Technical Memorandum

Review and Reevaluation of Skagit River 1921 Flood Peak Discharge

Figure 7. 1921 and 2003 HWMs in the Dalles gorge (original source of data: USGS-provided spreadsheet – Concrete_03_SAM.xls)

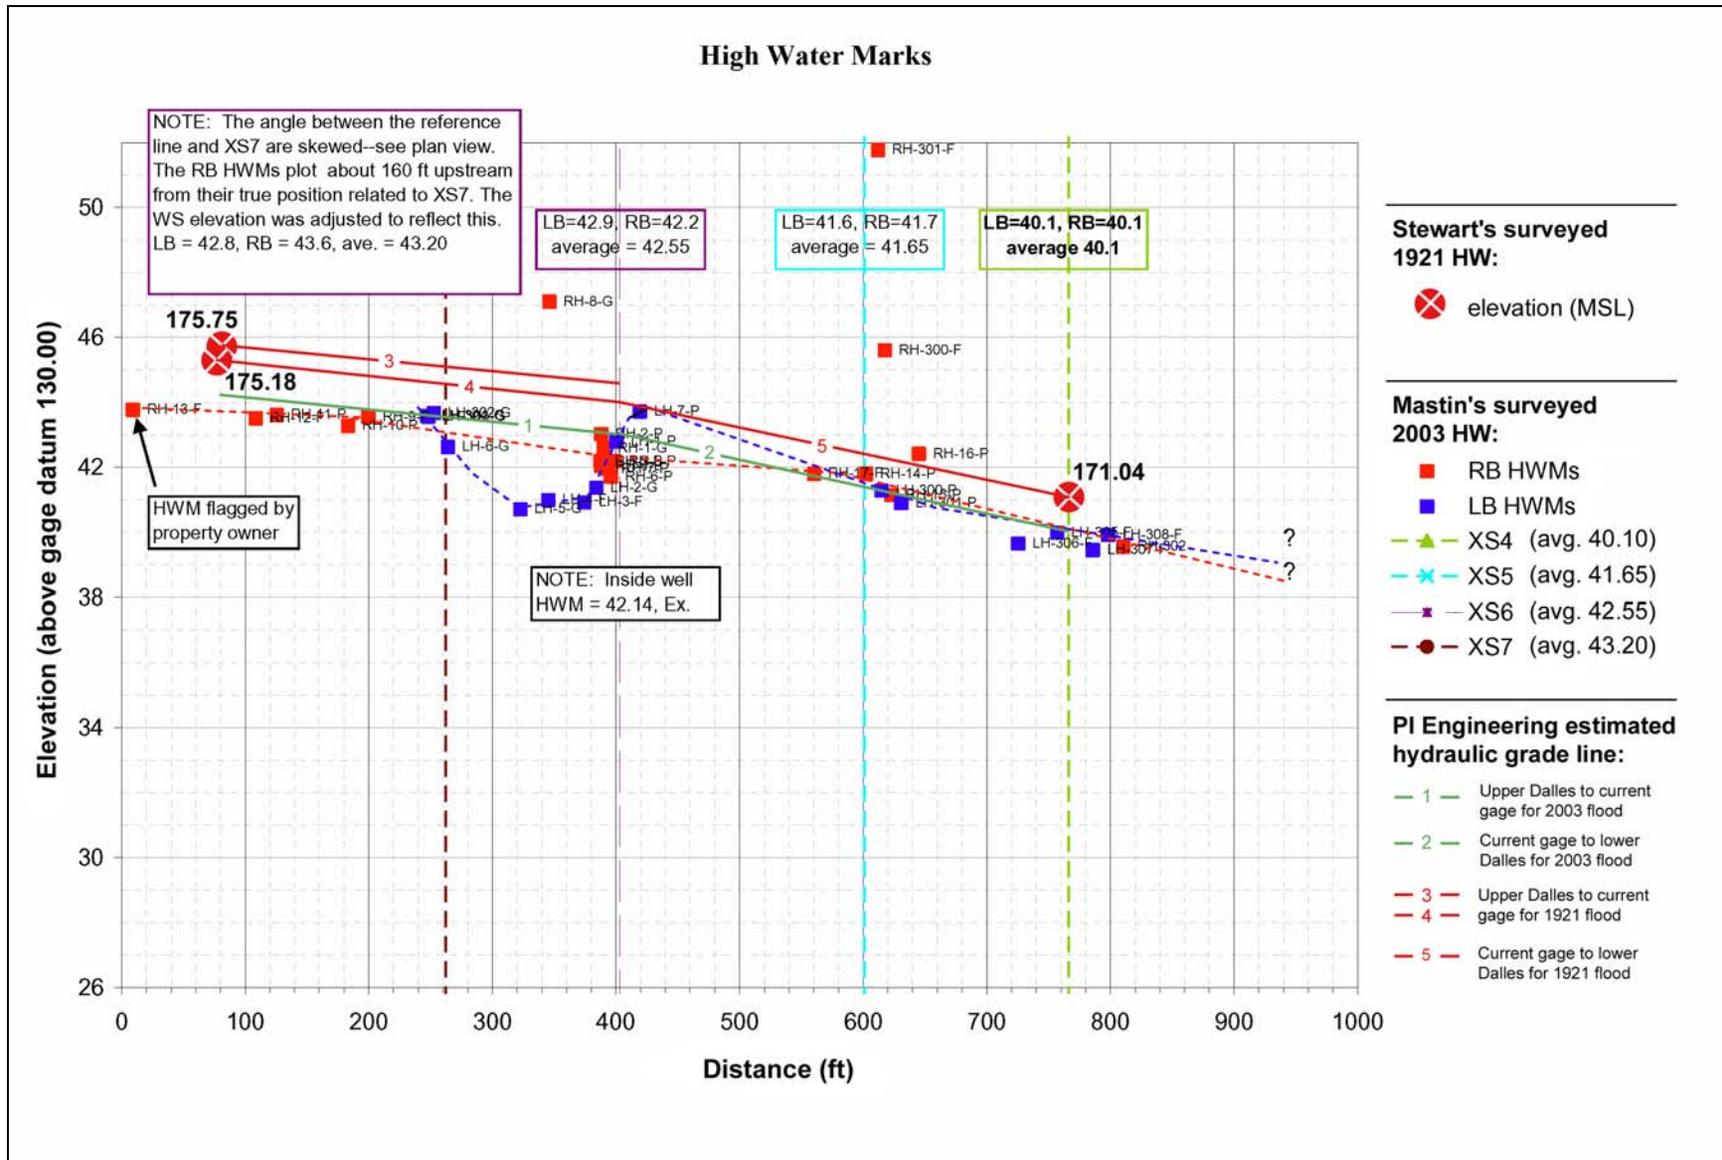
Three Stewart-surveyed 1921 HWMs (expressed in MSL) are shown in Figure 7 (an enlarged plot of Figure 4 showing only HWMs in the Dalles gorge), including 175.18 and 175.75 at his upper Dalles gage and 171.04 at his lower Dalles gage. Stewart noted that the upper Dalles is 695 ft above the lower end of the Dalles (Stewart's survey notes, p. 62). Figure 7 shows that the current gage (XS6) is located approximately 365 ft above the lower Dalles (XS4). This leads to an estimated distance of 330 ft between Stewart's upper Dalles gage and the current gage (which is more than "*about 200 feet above present gage*" stated by the USGS-published Water Supply Paper 612 (USGS 1925, p. 62)).

To transfer Stewart's HWMs from the upper and lower Dalles to the current gage site, we first estimate two hydraulic grade lines between the upper Dalles and the current gage, and between the current gage and the lower Dalles, using the USGS-surveyed 2003 HWMs. These two hydraulic grade lines are plotted in Figure 7 (green lines 1 and 2). The 1921 flood hydraulic grade lines are expected to be closely parallel to the estimated 2003 flood hydraulic lines, as the channel geometry through the Dalles did not substantially change at high flood stages over the last 80 years, and the difference between the USGS-published 2003 and PI Engineering-estimated 1921 flood peak discharges is not substantial. As shown in Figure 7, parallel lines (red lines 3, 4 and 5) are drawn to connect each of the three Stewart-surveyed 1921 HWMs to the current gage site. The estimated 1921 HWMs at the current gage site are thus determined by the elevation points where the hydraulic grade lines intersect the XS6 vertical line. Table 8 lists Stewart's HWMs at the Dalles and the estimated 1921 HWMs at the current gage site. As shown in the table, the estimated 1921 HWMs at the current gage are between 174.00 and 174.57, averaging 174.19 (or 44.19, rounded to 44.2, above the current gage datum 130.00).

The amount of surging for the 2003 flood is estimated to be 0.9 to 1.6 ft at the gage site, based on the USGS-surveyed HWMs (see Figure 7, the 0.9 to 1.6 range calculated between HWMs inside well HWM = 42.14 and outside well HWMs = 43.021 and 43.715 for surveyed points RH-2 LH-7, respectively). This estimated range of surges is probably reasonable as the flow velocity is very high, estimated to be approximately 15 ft/sec (cross section average, and equivalent to a velocity head of 3.5 ft, at the current gage site) based on a HEC-RAS model (PI Engineering 2008, Section 3.2.5). Conservatively using 0.5 ft for the estimated amount of surging for the 1921 flood at the current gage site, the 1921 flood stage inside the gage would be 173.7, or 43.7 above the current gage datum of 130.00.

Figure 8. Stage-discharge Rating Curve for the Skagit River near Concrete (provided by USGS, May 2004)

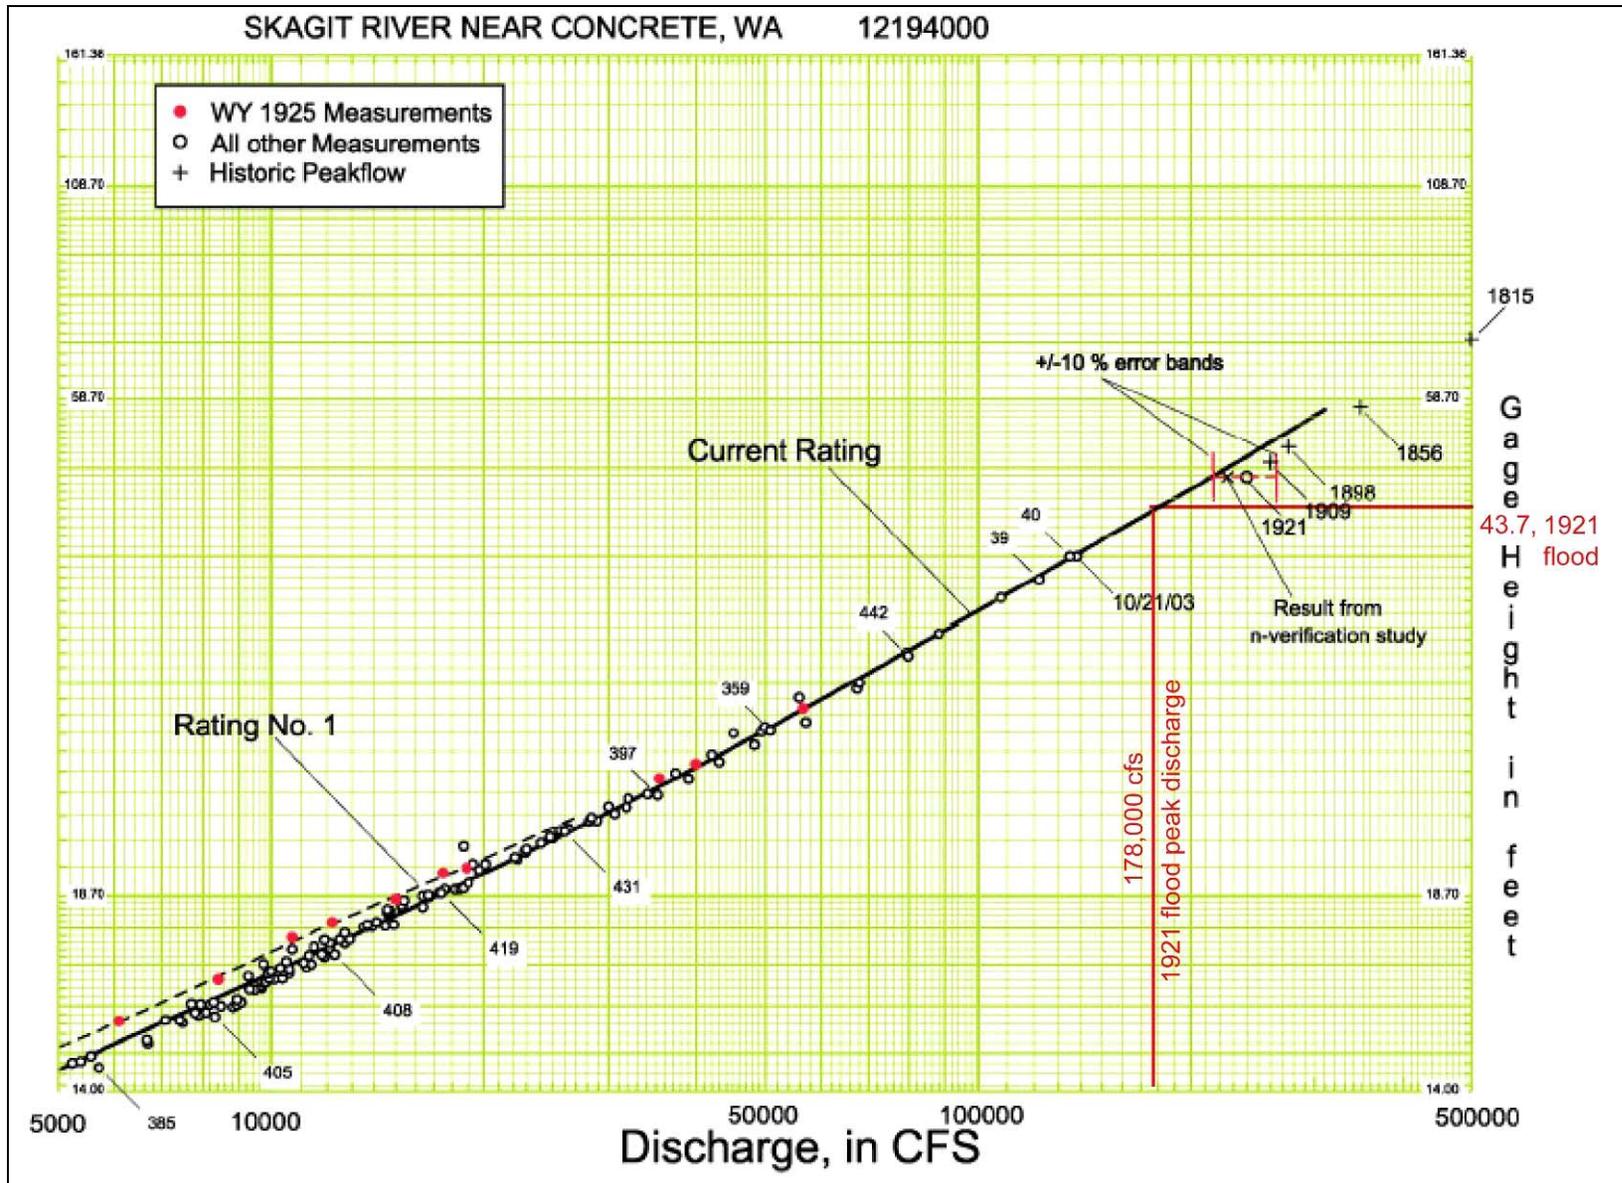
Figure 8 shows the stage-discharge rating curve for the current gage. Based on the estimated 1921 gage height of 43.7 at the gage, the 1921 flood peak discharge is estimated to be 178,000 cfs, which is 8,300 cfs above 169,700 cfs estimated in 2008 by PI Engineering (see Table 1), or a difference of less than 5 %, which is within the accuracy of this reevaluation.
